CCO #EC-002

Project: AS7.001.001 - Ogdensburg CSD Capital Improvement Project
 1100 State Street
 Ogdensburg, New York 13669

**Change Order Authorization #EC-002:
 CE #029 - #Ph1-35: CH-RFI-006 Create Room Panel**

POWER SYSTEMS & LIGHTING PLAN - FIRST FLOOR

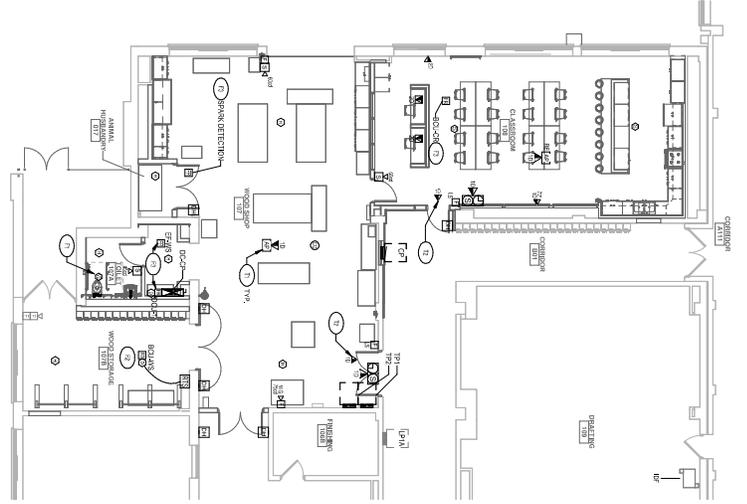
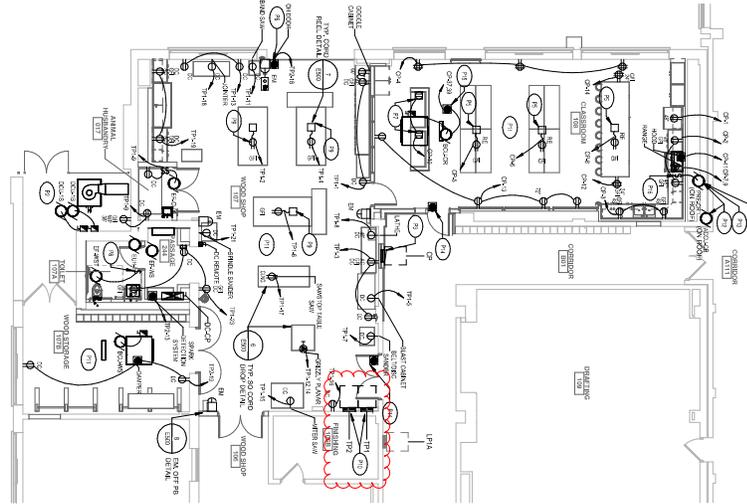
Description of RFI: Replace panels TP1 & TP2. Keynote 10 calls to reuse, extend feeders to TP1 and provide new 225a breaker and feeders for TP2. New TP1 is a 400amp panel.
The conductors currently feeding existing TP1 are rated for only 100amps.

Response: A field inspection with Collins Hammond on 10/21/25 confirmed new panel location TP1 is feed with an MDP 200A breaker with a 150A wire. Direction as follow:

- 1. For Panel TP1: Provide Material and Labor to replace existing 200A3P breaker with a 150A3P breaker and use existing feeder to feed panel.
- 2. For Panel TP2: Provide Material and Labor to install 4-#2 with 1-#8 ground in 1 1/2" conduit from same panel feeding TP1 to new panel TP2, connect to spare 100A3P breaker in panel (breaker number 6).

Follow up response to reopened RFI 35 11/12/25; Please note change in direction regarding the Create Area electrical panels TP1 & TP2:

- 1. For Panel TP1: Provide material and labor to install 4-#250mm with 1-#4 ground in 2 1/2" conduit from panel at Electric Room E005 (same panel used to feed new panel TP2) to new panel TP1. Replace existing spare 100A3P breaker in panel with a new 225 amp 3 pole breaker (breaker number 6).

Signed: SV/SES 2. For Panel TP2: Provide material and labor to replace existing 200A3P breaker with a 150A3P breaker and re-use existing cabling to feed panel.

Date: 10/22/25 Note: No changes are needed to the TP1 or TP2 schedules; and adequate capacity is provided for future loads / equipment. The name plate on Panel TP1 should be provided to state the following: "PANEL IS FED FROM 225 AMP BREAKER IN ELECTRIC ROOM"; while Panel TP2 should be provided to state the following: "PANEL IS FED FROM 150AMP BREAKER IN ELECTRIC ROOM"
